ADDENDUM NO: 04

DATE OF ADDENDUM: 11/25/2014

**Hammonasset Beach State Park West Beach Improvements
Madison, CT
BI – T – 603**

Sheet No.: **C.101**

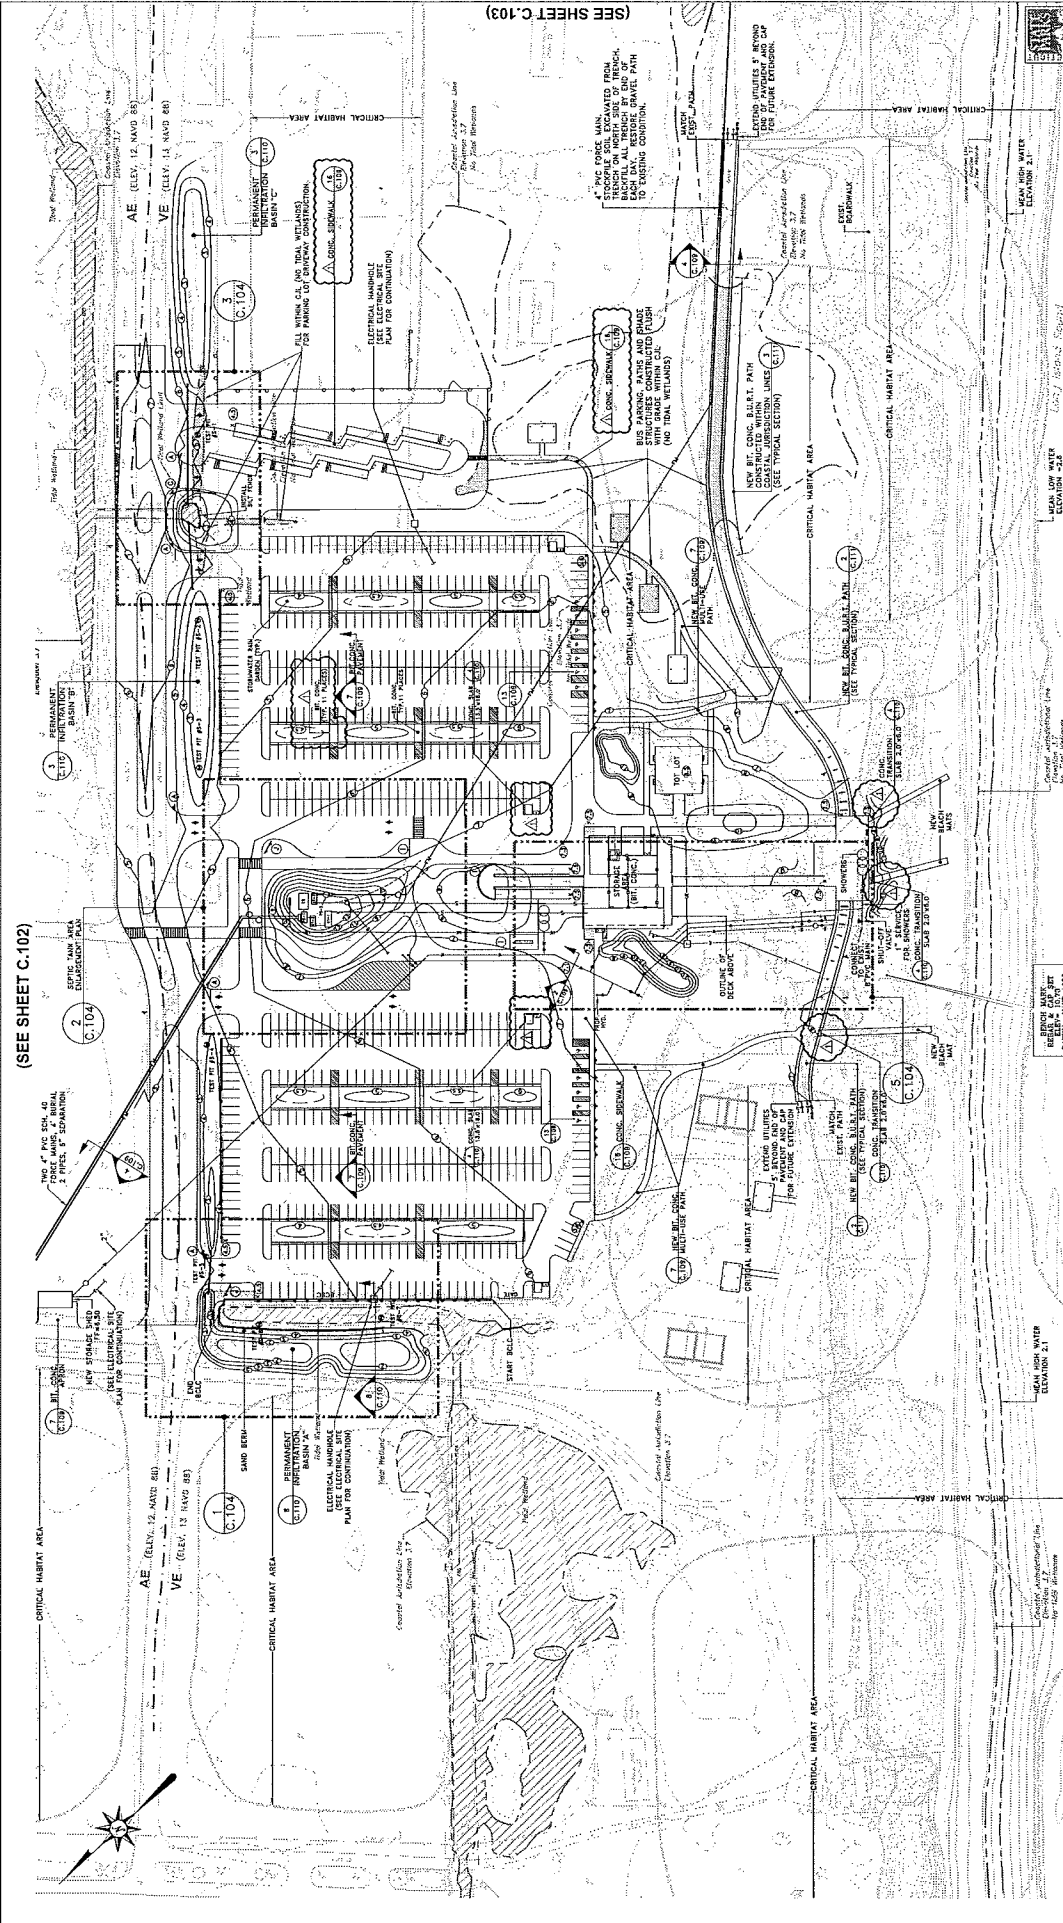
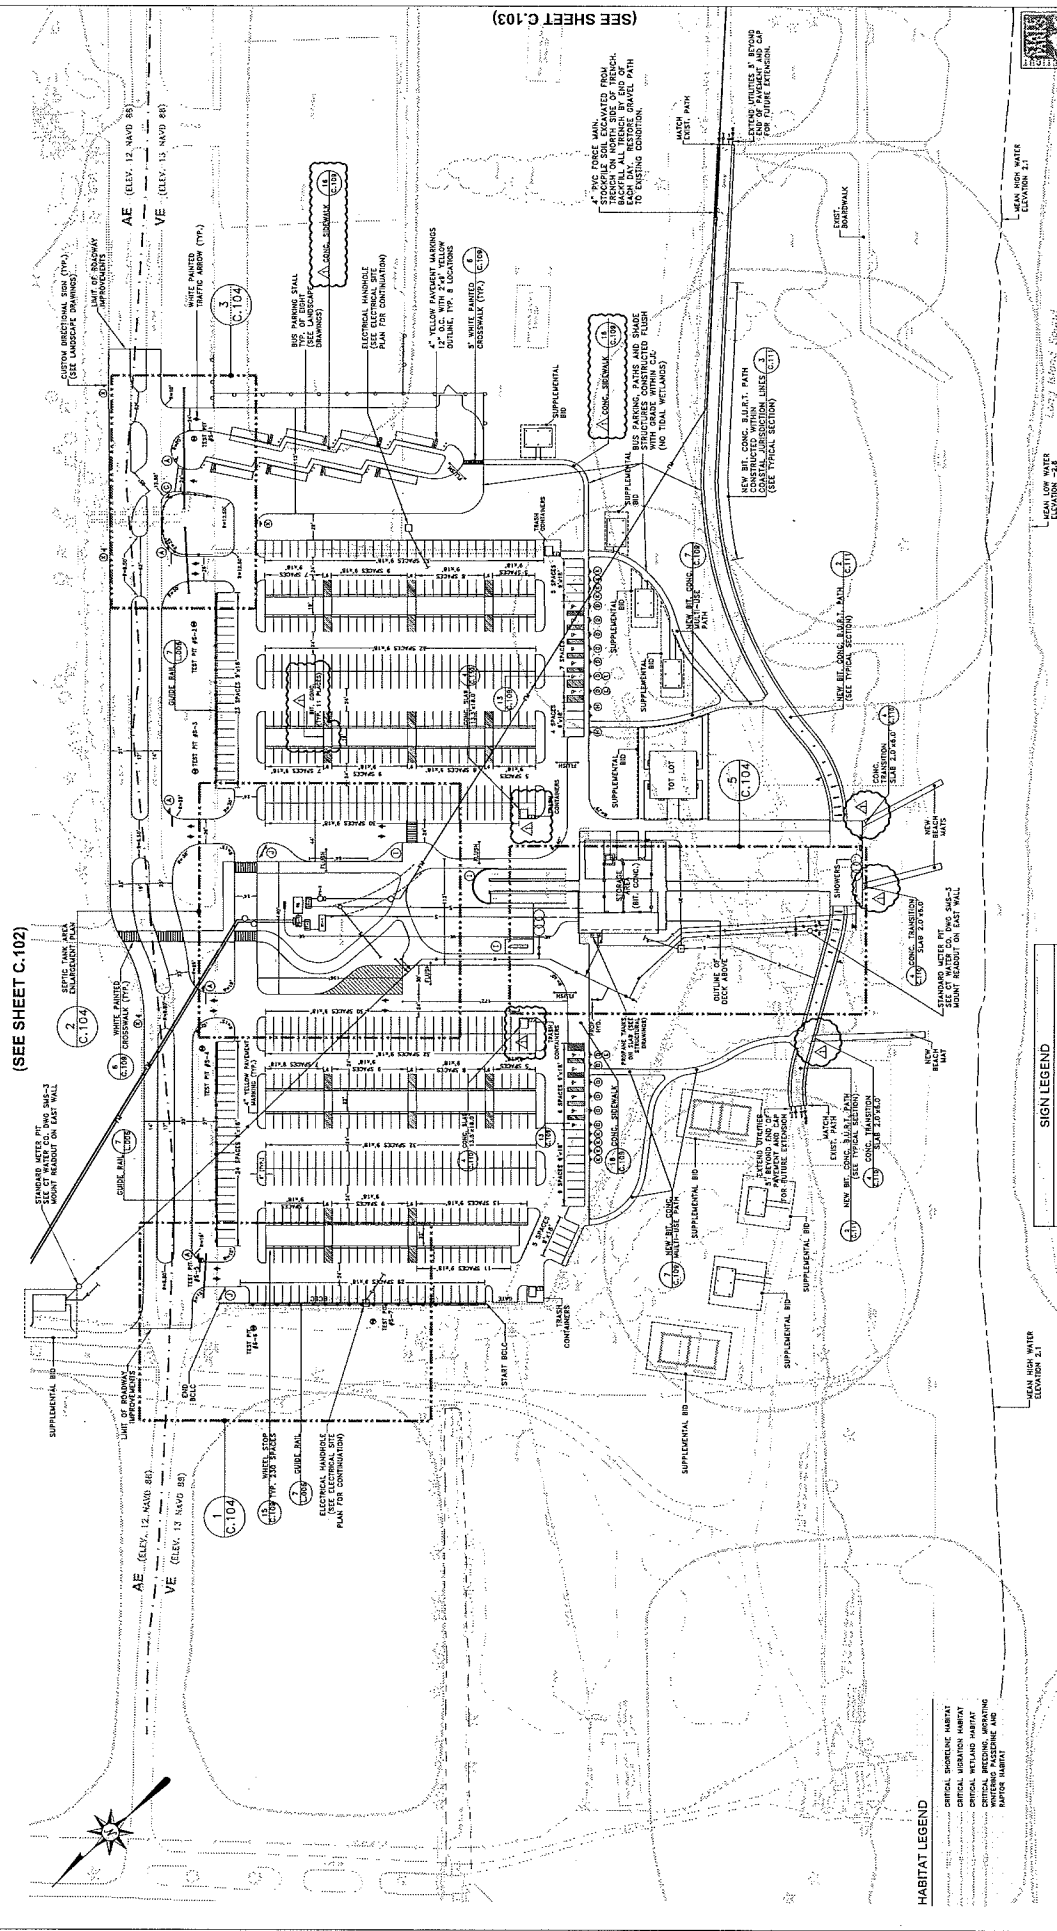
SHEETS C.001 AND C101- SITE PREPRATION PLANS

Grove of Trees in the location of the "Tot Lot" and the grading is shown as a tree line. Survey does not locate all individual trees. All trees within the tree line that interfere with new work, must be removed to complete construction of the Tot Lot.

Section 31 10 00 Site Clearing requires removal of all trees, shrubs and vegetation as required for construction.

Trees not labeled to remain or to be removed shall be removed if required for construction.

Existing Septic Tanks to be removed are assumed to be 5,000 gallon tanks.

Existing Leaching Field is located to the north of the east septic tank; distribution box is assumed to be a standard 4 ft. by 4 ft. by 4 ft. pre cast concrete with duel inlets and multiple outlets.

At removed septic tanks, piping and distribution box contractor shall backfill and restore area per the following;

Excavations made for removing septic tanks, distribution boxes and pipes are to be backfilled to subgrade with "satisfactory soil" meeting the requirements of Spec Section 31 20 00, Part 2, Subsection 2.1.B. Excavations are to be backfilled according to Spec Section 31 20 00, Part , Subsection 3.9. Backfill is to be compacted according to Spec Section 31 20 00, Part 3, Subsection 3.14. Sand and beach grass within these areas shall be restored.

Project Name: State Park West Beach Improvements
Client: State Park West Beach
Location: State Park West Beach
Scale: 1" = 15'-0"
Sheet No: 11-1344-01
Project No: C.101A

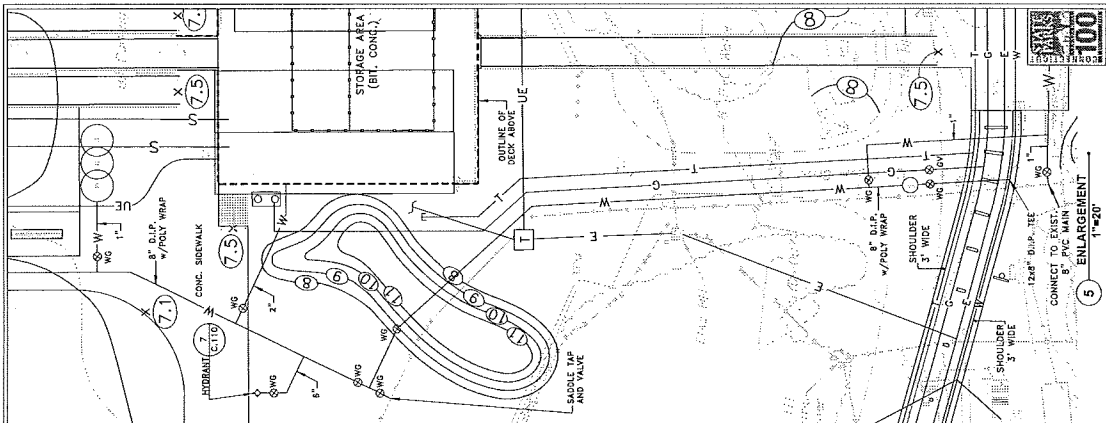
SHEETS C.001A SITE LAYOUT

Clarification: Base Contract includes water line to location of proposed Water Meter Pit adjacent to the Storage Shed. Water meter, meter, and connections are part of Supplemental bid for Storage Shed.

PROJECT NO. HW-1210-03
DRAWING NO. C.104

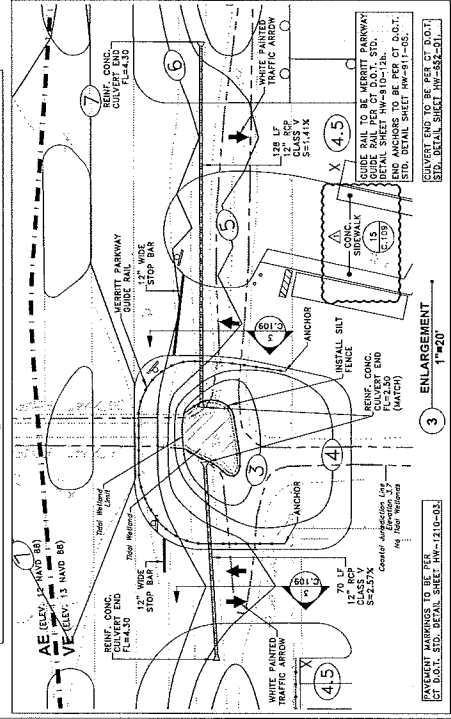
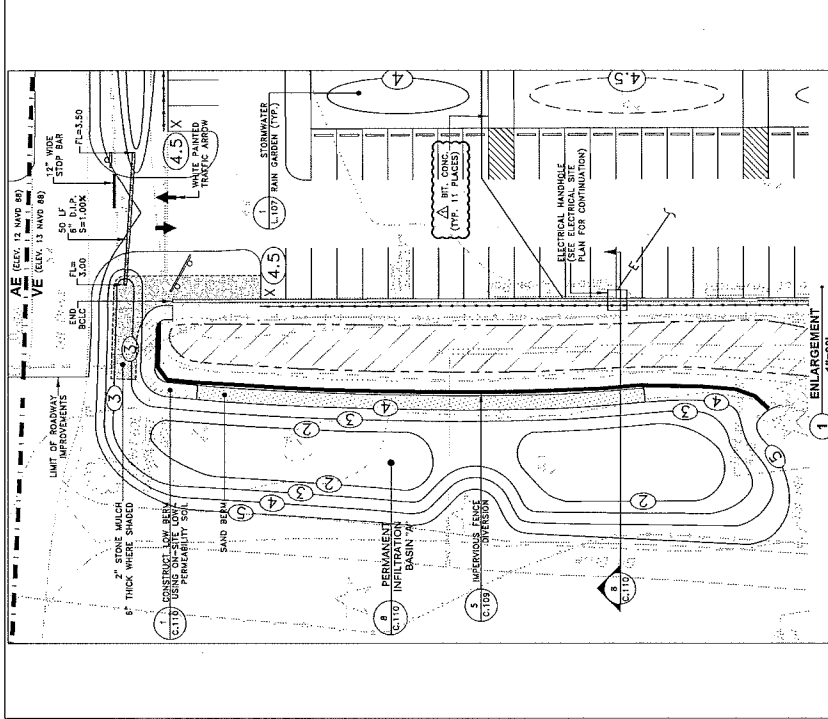
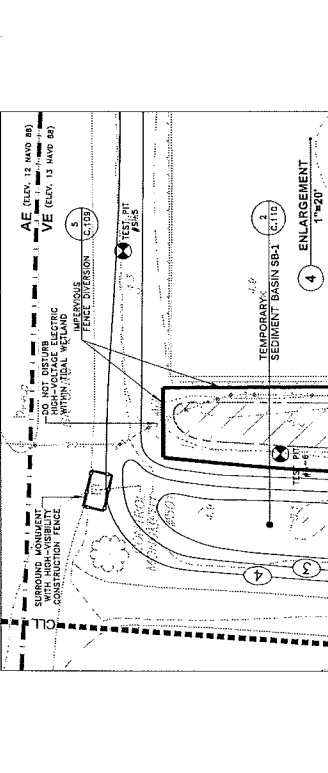
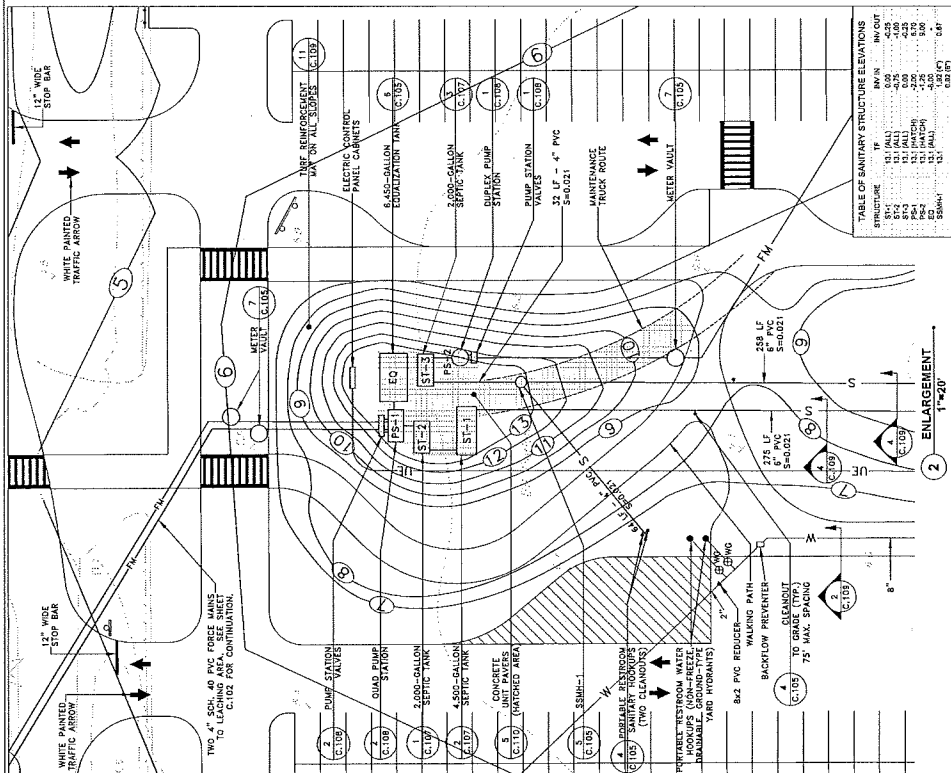
ALL CIVIL SHEETS C.001, C.002, C.003, C.101, C101A, C102, C104, C 105, C108, C111

Clarification: All electrical work indicated on the above Civil Drawings are part of the electrical contractor's scope.
